**TITLE 45
LEGISLATIVE RULE
DEPARTMENT OF ENVIRONMENTAL PROTECTION
AIR QUALITY**

**SERIES 16
STANDARDS OF PERFORMANCE FOR NEW STATIONARY SOURCES**

SUMMARY: This action finalizes amendments to the petroleum refinery National Emission Standards for Hazardous Air Pollutants (NESHAP) (referred to as Refinery MACT 1 and Refinery MACT 2) and to the New Source Performance Standards (NSPS) for Petroleum Refineries to clarify the requirements of these rules and to make technical corrections and minor revisions to requirements for work practice standards, recordkeeping, and reporting which were proposed in the **Federal Register** on April 10, 2018. This action also finalizes amendments to the compliance date of the requirements for existing maintenance vents from August 1, 2017, to December 26, 2018, which were proposed in the **Federal Register** on July 10, 2018.

Figure 8-1. Sulfuric Acid Sampling Train

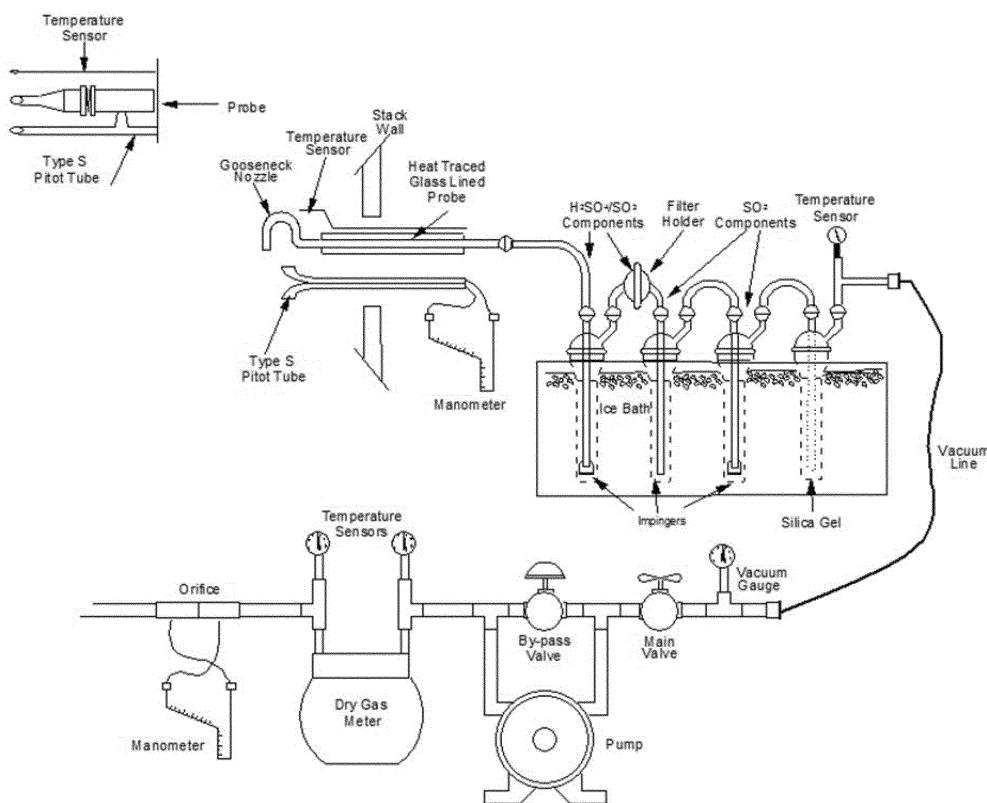
As proposed, Method 8, sections 6.1.1.1 through 6.1.1.4 are renumbered to 6.1.1.2 through 6.1.1.5; a new section 6.1.1.1 is added to clarify the requirements that apply to the probe nozzle; and, in response to comments, Figure 8-1 (Sulfuric Acid Sampling Train) is corrected by: (1) Modifying the impinger graphics to make it consistent with the text in section 6.1.1.4 and (2) revising the proposed label S-Type Pitot Tube to Type S Pitot Tube for consistency. The proposed first sentence in section 6.1.1.1 is revised to “Borosilicate or quartz glass with a sharp, tapered leading edge and coupled to the probe liner using a polytetrafluoroethylene (PTFE) or glass-lined union (e.g., fused silica, Silico, or equivalent).” Based on a public comment that recommended adding Silco coated stainless steel unions as an option for Teflon unions, and for consistency with other test methods, we have replaced Teflon with the generic option polytetrafluoroethylene (PTFE).

- b. Redesignate sections 6.1.1.1 through 6.1.1.4 as sections 6.1.1.2 through 6.1.1.5 in Method 8.
- c. Add a new section 6.1.1.1 in Method 8.
- d. Revise Figure 8–1 in Method 8.

Figure 8.1. Facility with a Regular Shape Between 750 and 1,500 Acres in Area

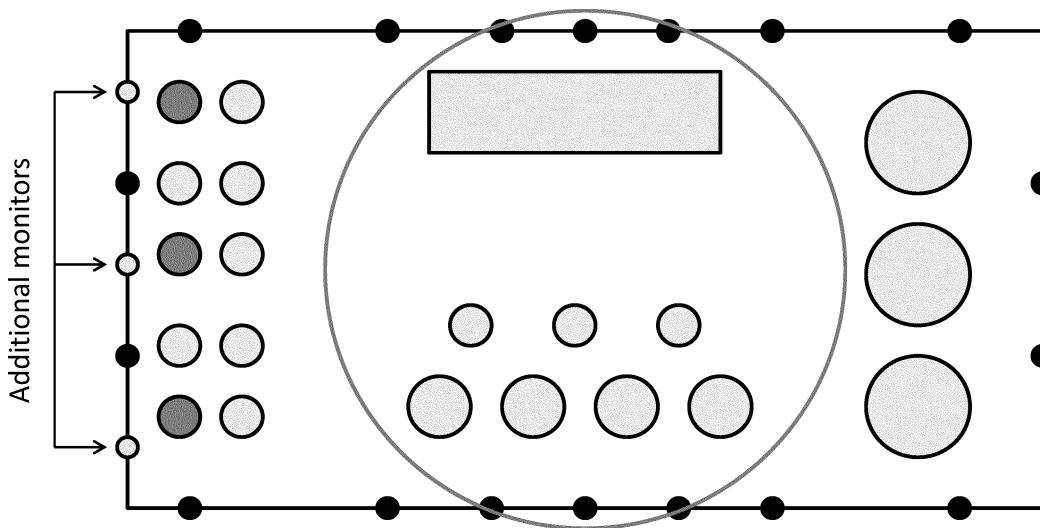
- h. Revise section 8.2.1.3, Figure 8.1, and section 8.2.3.2 in Method 325A.
 - i. Add sections 8.2.3.3 and 8.4.3 in Method 325A.
 - j. Revise sections 9.3.2, 9.13, 11.3.2.5, and 12.2.2 in Method 325B.
 - k. Remove sections 12.2.3 and 12.2.4 in Method 325B.
 - l. Revise table 17.1 in Method 325B.
- The revisions and additions read as follows:

account for known sources of VOCs. For example, in Figure 8.1, the facility added three additional monitors (*i.e.*, light shaded sampler locations), and in Figure 8.2, the facility added two additional monitors to provide sufficient coverage of all area sources.
